Certificate of Derogation from a Notified National Technical Rule

Deviation Number: **12/168/DGN**

Derogation to Engine Exhaust Requirements defined in GM/RT2130 Issue 3 Clause 3.1.

Windhoff Multi-Purpose Vehicle (MPV).

Figure 2

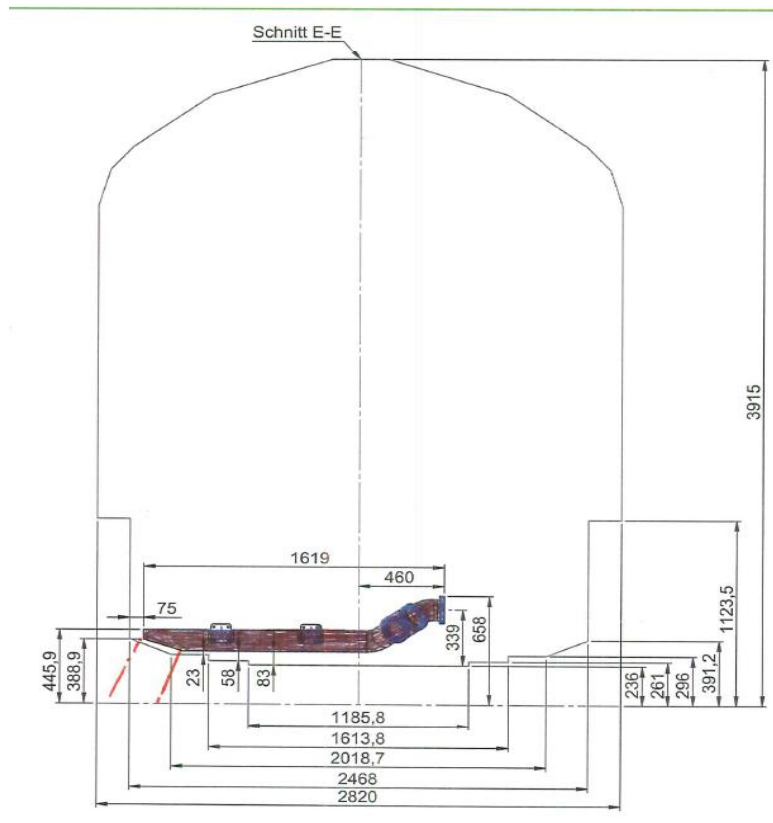
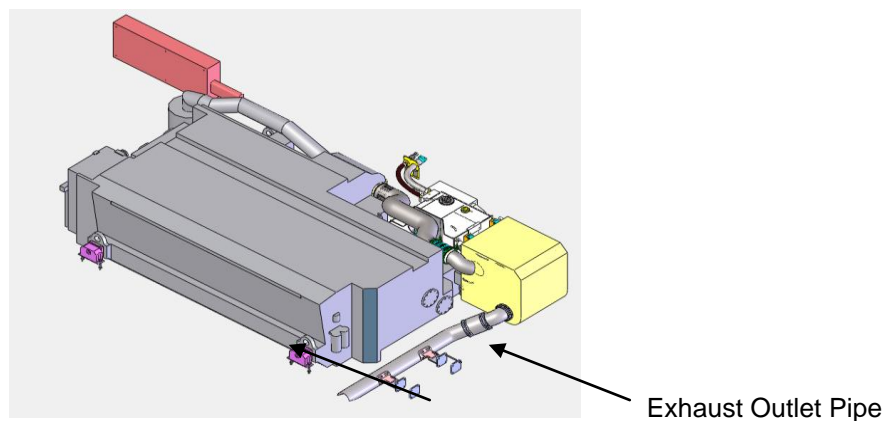
The Windhoff Multi-Purpose Vehicle (MPV) will operate in transit mode on the Network Rail Managed Infrastructure as well as self-powered within a Possession. The MPV Main Engine exhaust direction is as depicted in Figure 2 below and is therefore in an area that GM/RT2130 states should be avoided.

The MPV main engine is under floor mounted between the bogies. The exhaust system outlet is downwards towards the track and outwards as depicted.

The MPV design concept for the construction and maintenance of the upper part of the railway infrastructure in terms of the modules that can be accommodated would be severely compromised if the exhaust system outlet was in compliance with GM/RT2130. The primary purpose of the HOPS is to construct the Overhead Line Equipment and supporting structures and requires machinery and operative to work at height. A number of structures would be required to facilitate the installation of a compliant exhaust system and this would severely impact the functionality of the HOPS MPV.

The proposed alternative action is to design the MPVs with the same exhaust system outlet design (Figure 2 above) used on MPVs that construct and maintain the upper part of the railway infrastructure. Summary details are (non-exhaustive listing):

The performance requirements of the HOPS has resulted in the selection of an exhaust outlet direction that is proven in application and accepted as in compliant with European Standards. However, the impact of using this design has been considered and the following summarises this work:

On the basis of the above, the Operator of the High Output OLE Construction System (HOPS) has concluded that, in terms of safety risk, although non-compliant with RGS, the primary requirement for construction and maintenance of the upper part of the infrastructure application, the under floor exhaust is the best option and poses acceptable risk.
